Keeler to Tillamook Transmission Line Rebuild Project

Final Environmental Assessment

Bonneville Power Administration
DOE/EA-1931
January 2014

Public Comments and BPA's Responses

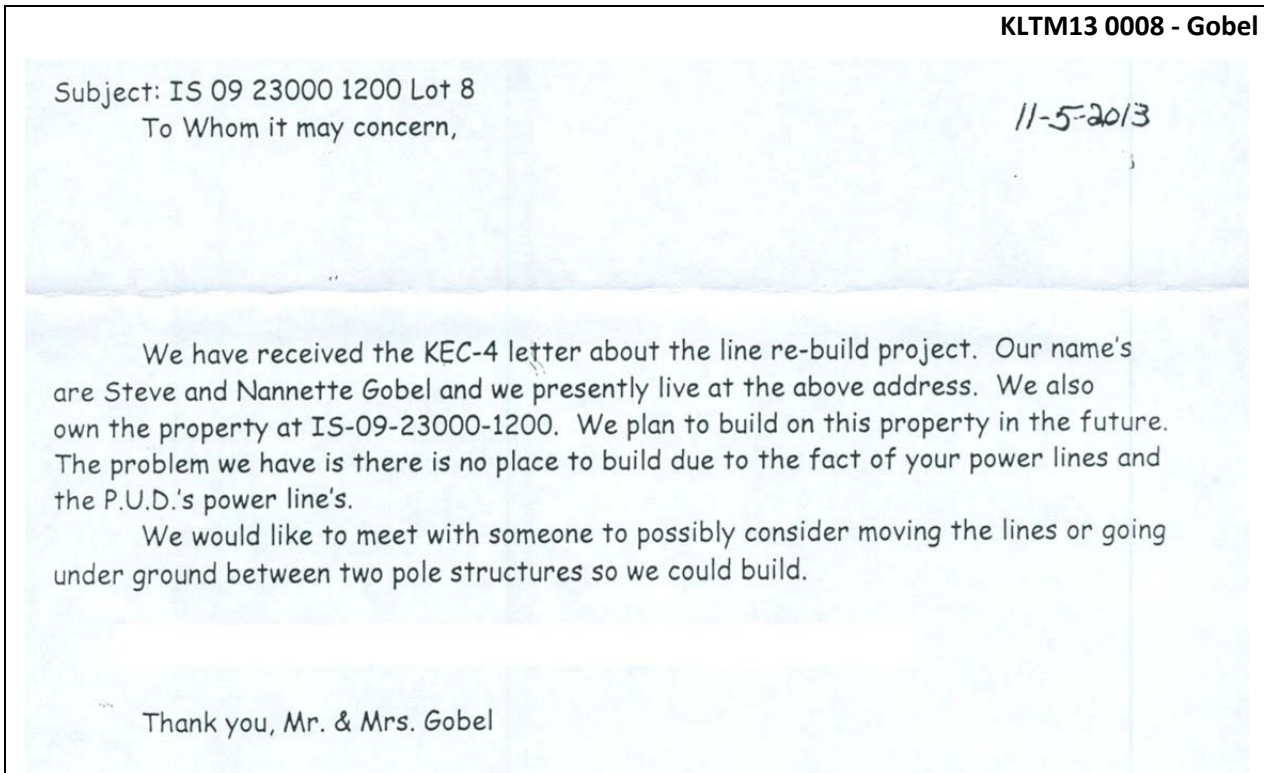
BPA is providing an updated Figure 3.7-1d, adding Slide Creek, between Smith Creek and Fern Creek, east of the marker for Line Mile 40. This is in response to a comment received during the Draft EA comment period. BPA has also addressed the potential project-related effects on Slide Creek in its response to comment below. (Note: there is also a second Slide Creek shown on this figure, west of Beaver Creek. This is a separate waterway.)

Slide Creek, at about mp 9.5 is a water source for several hours. Please don't use chemicals or pollutants in that watershed.

Slide Creek is located between Smith Creek and Fern Creek, east of Line Mile 40. Slide Creek was previously not labeled on Figure 3.7-1d of the Draft EA; however, as noted above, Slide Creek has now been added to the revised Figure 3.7-1d. No structure replacements or access road work will occur within 100 feet of Slide Creek; as such, it was not listed in Tables D-1 or D-2 (Appendix D). The closest structure is 39/3 of the Forest Grove-Tillamook Line, located approximately 190 feet east. The closest access road work is at the same location, structure 39/3. Impacts to Slide Creek are not expected because the transmission line spans the creek and construction work would be located more than 100 feet away.
